Subject: RE: Follow up on our conversation on FSRU Port Kembla [External Sender]

1. LSIR encroaching to PKCT existing truck wash area.

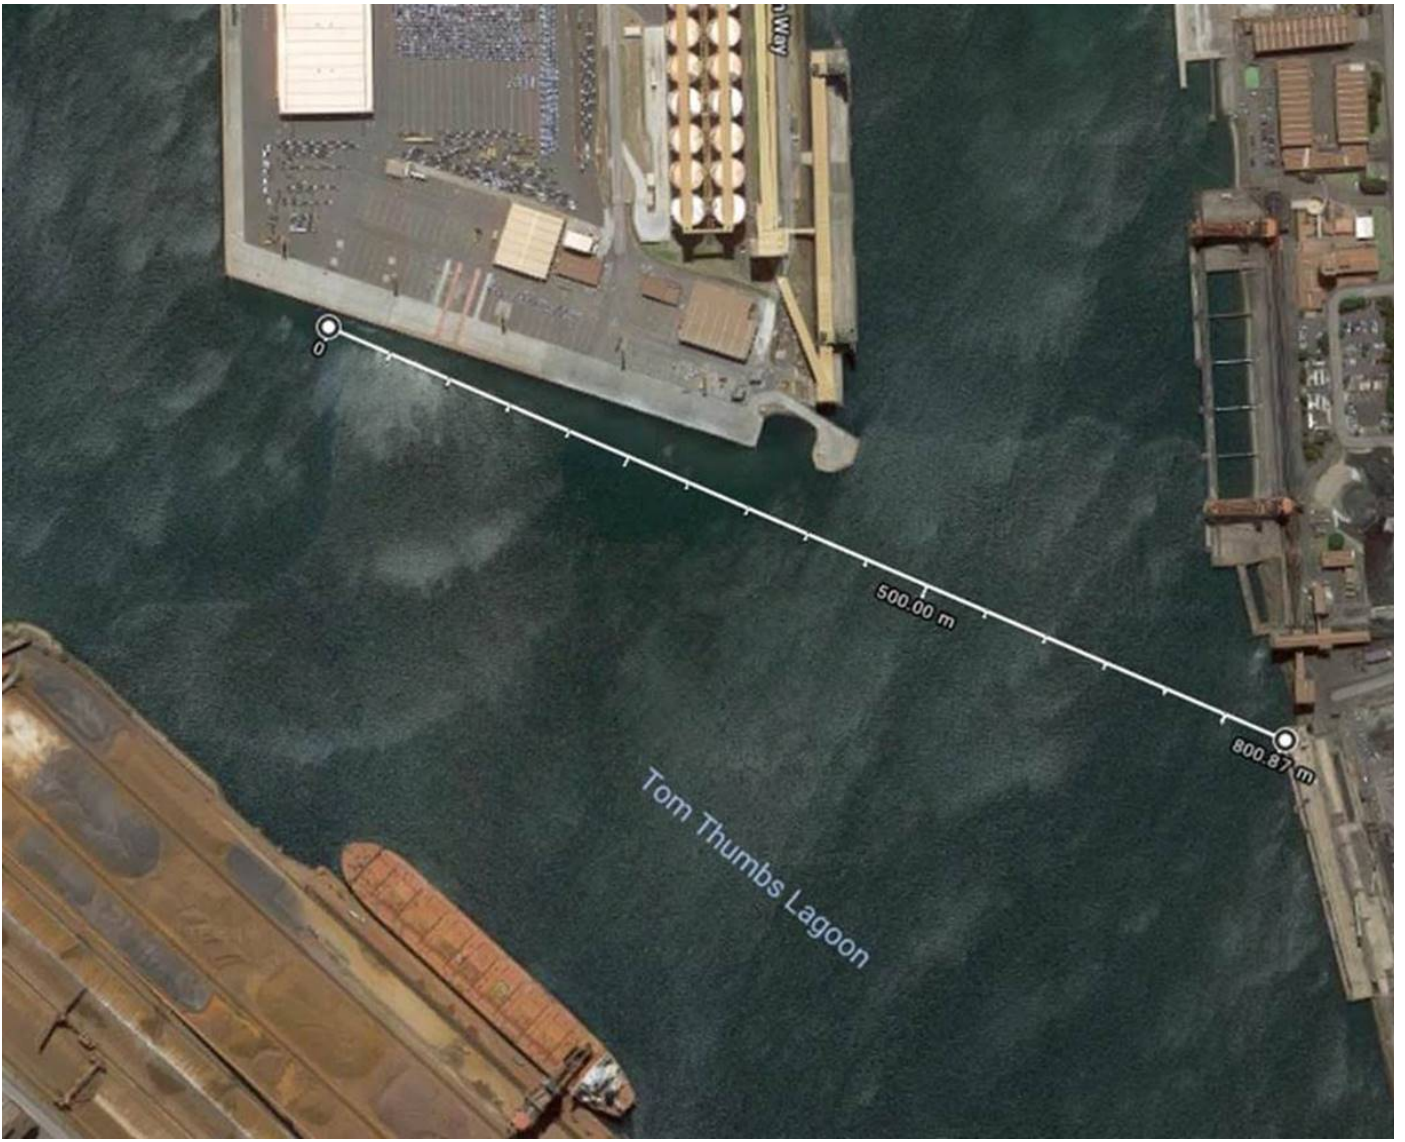
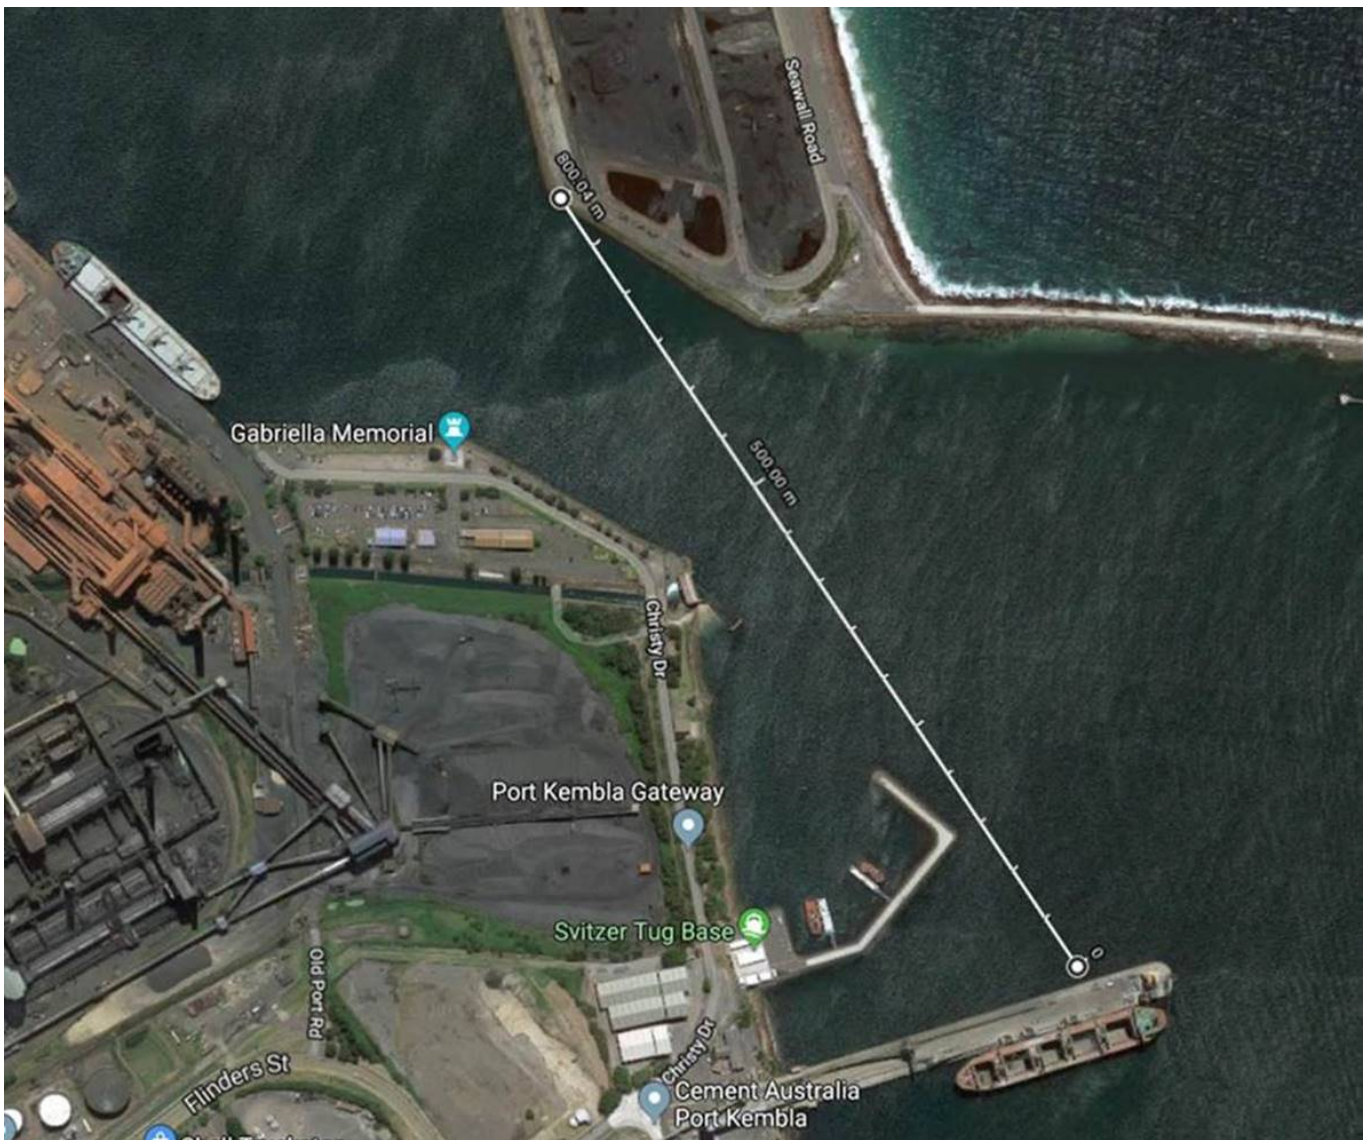
2. Dangerous Goods handling at other berths.

Studies have shown that the ignition of small arms cartridges, produces no explosion overpressure or projectiles at high velocity. The Fridley Minnesota Fire Department in July 1983 conducted various ammunition impairment tests with 281,000 rounds of ammunition containing more than 180 kg of power.

One of the tests involved confined burning of ammunition placed in a specially built 6 x 6 foot concrete block structure with oil-soaked scrap timber stacked beneath the ammunition and a flat boilerplate placed on top of the structure to complete the confinement of the ammunition.

The outcome of the tests concluded that:

- When ammunition is involved in a fire, it will not mass detonate or explode.
- Projectiles from ammunition are at low velocity and do not present any significant hazard to firefighters wearing standard firefighting and face protection.
- Ammunition will not support its own combustion.

Therefore, shipments of small arms cartridges are not expected to generate damaging explosion overpressure toward the LNGC / FSRU.
